**TOWN OF NEWBURGH
PLANNING BOARD
TECHNICAL REVIEW COMMENTS**

PROJECT: WTF NY INC.
PROJECT NO.: 14-07
PROJECT LOCATION: SECTION 2, BLOCK 1, LOT 46 & 42
REVIEW DATE: 12 FEBRUARY 2016
MEETING DATE: 18 FEBRAURY 2016
PROJECT REPRESENTATIVE: TALCOTT ENGINEERING DESIGN

SURVEYOR	ENGINEER	CHARLES T. BROWN, P.E. P.O. BOX 4470 NEW WINDSOR, N.Y. 12553 LOT LAYOUT LOT LINE CHANGE FOR: WTF NY INC. 979 & 983 ROUTE 32 SBL: 2-1-42&46 TOWN OF NEWBURGH, ORANGE COUNTY, NY
		DATE: 03/25/14 SCALE: 1"=30' JOB NUMBER: 13072-WTF SHEET NUMBER: 1 OF 3

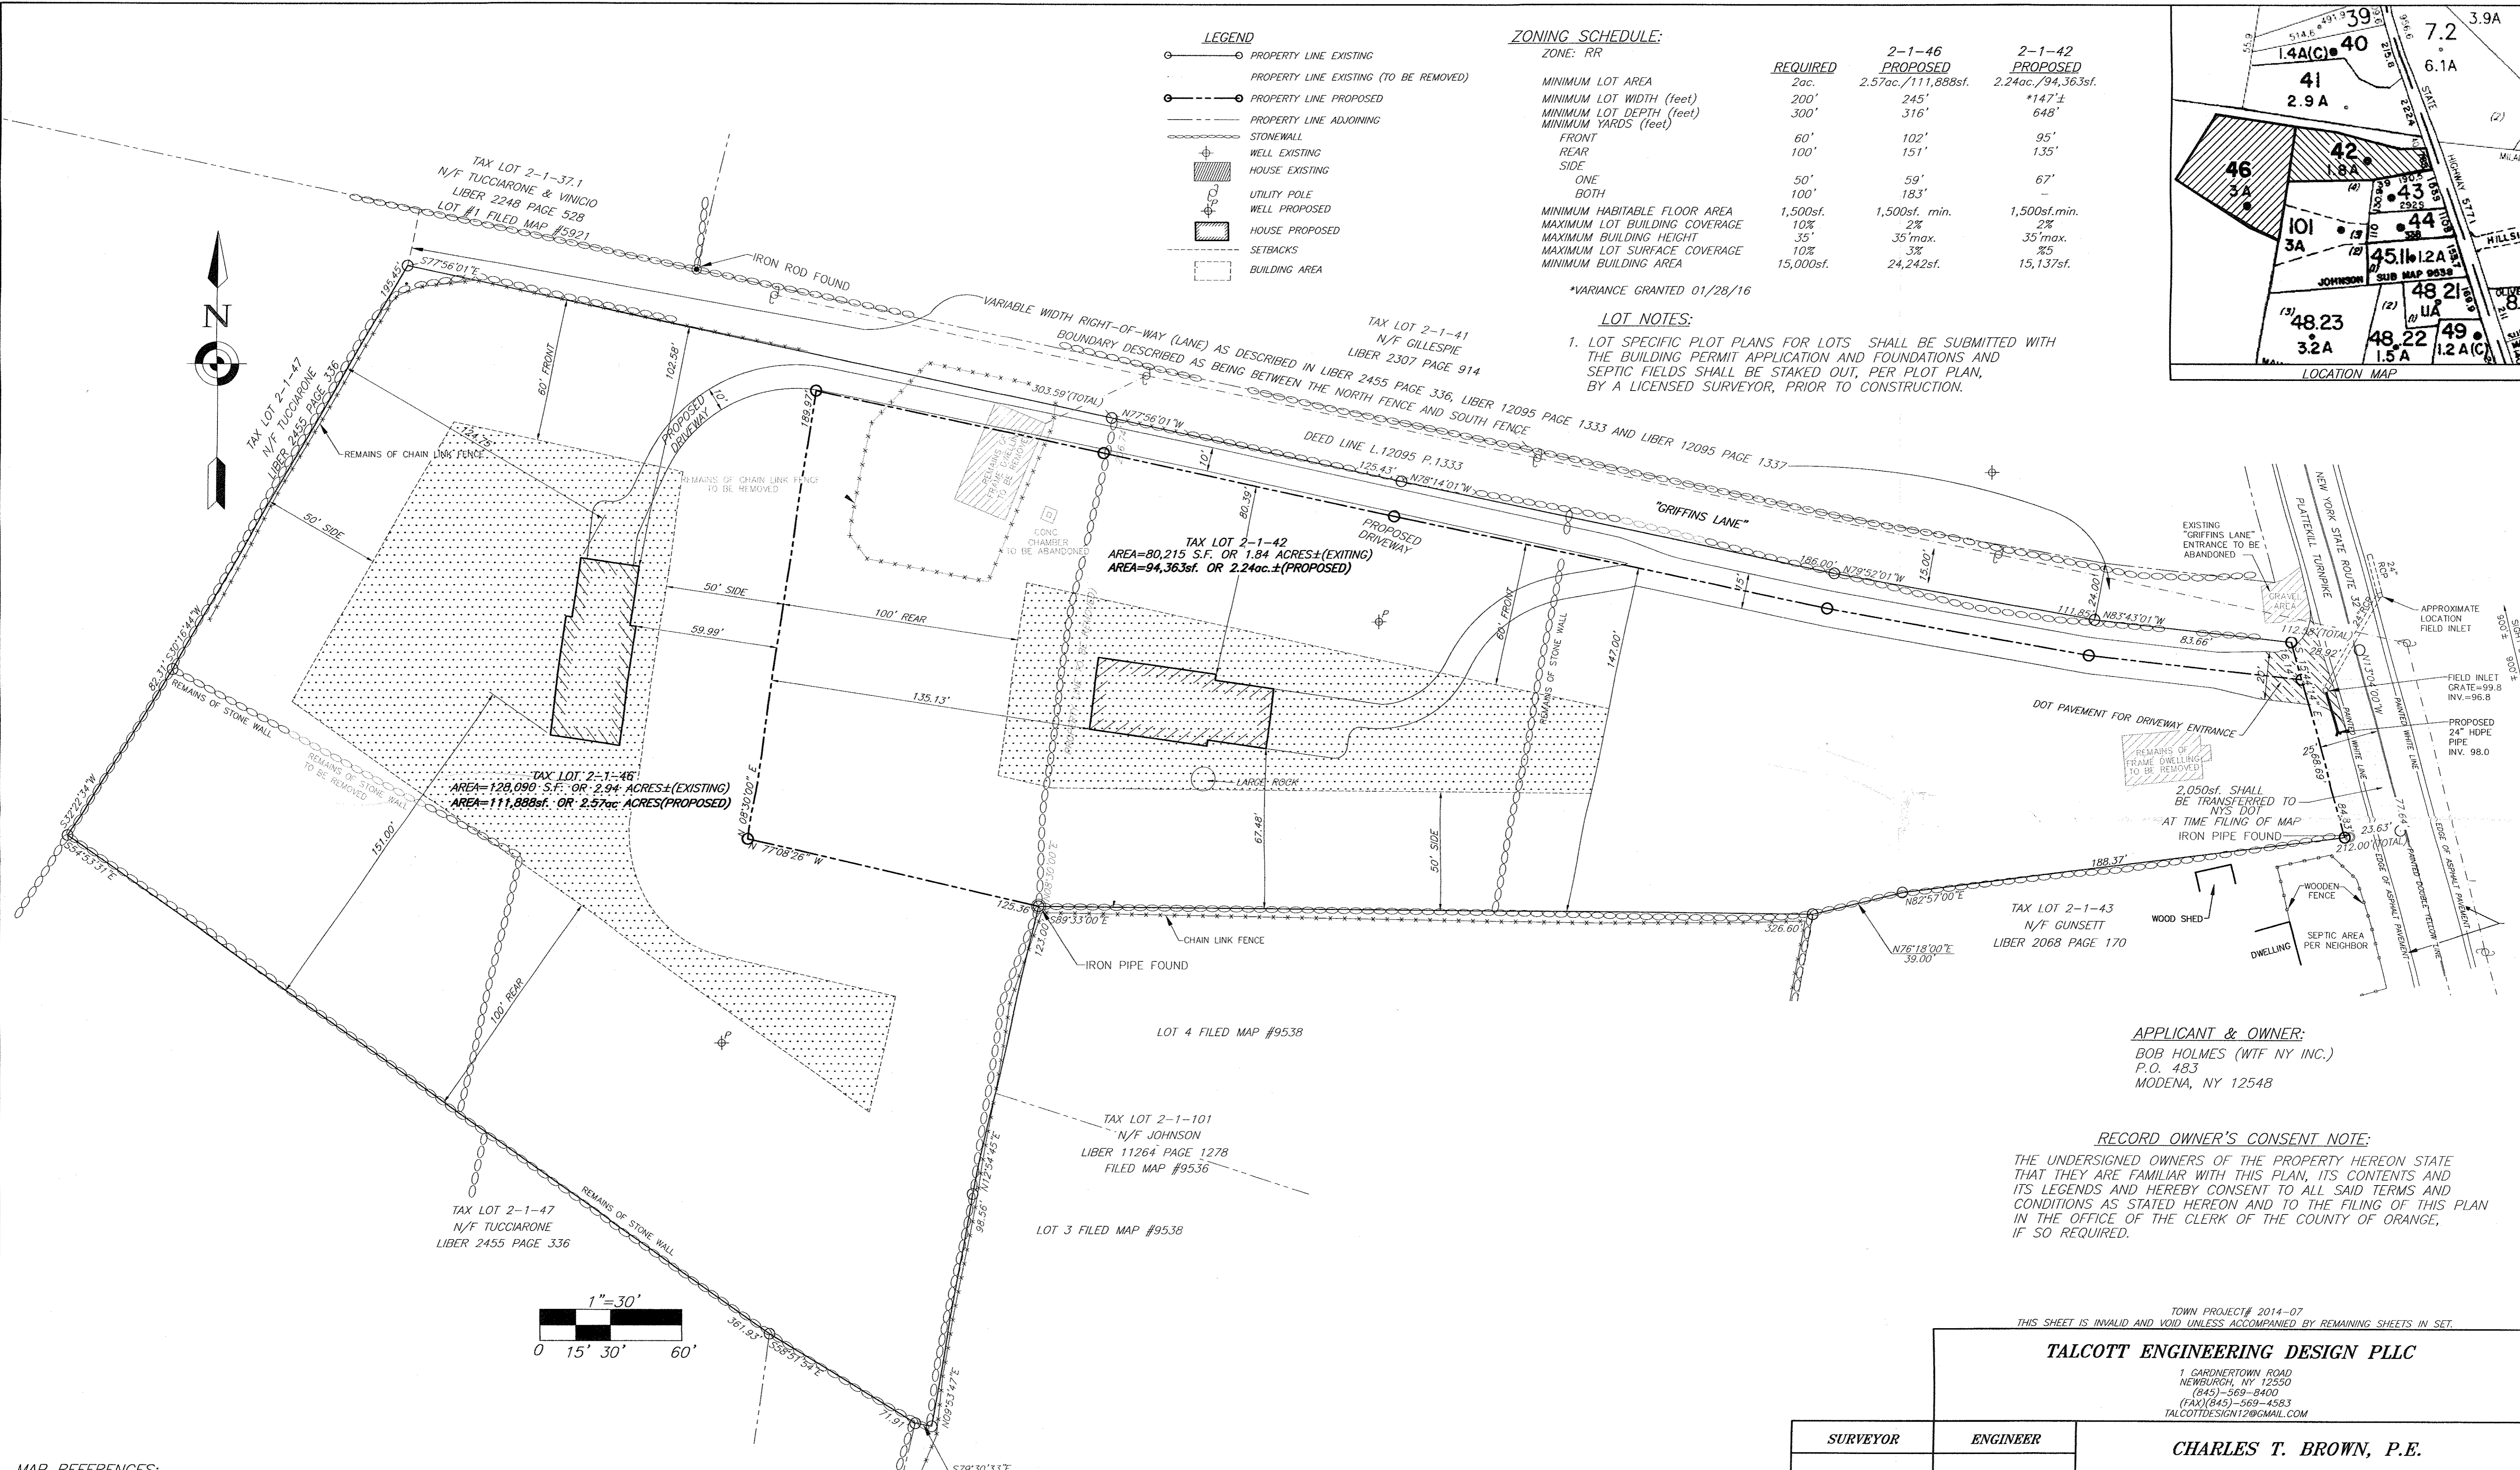
1. Plans should bear stamp of licensed surveyor.
2. NYSDOT approval for the driveway access and drainage pipe modification must be received.
3. An offer of dedication to DOT is included in the Lot line and must be approved by DOT.
4. Notes stating existing Griffins Lane entrance to be abandoned should be modified to state "will not be utilized by the 2 lots" subject to this, the area identified to be abandoned is within an adjoining lot, not party to this subdivision.
5. Common driveway access and maintenance agreement should be submitted to Mike Donnelly's office.
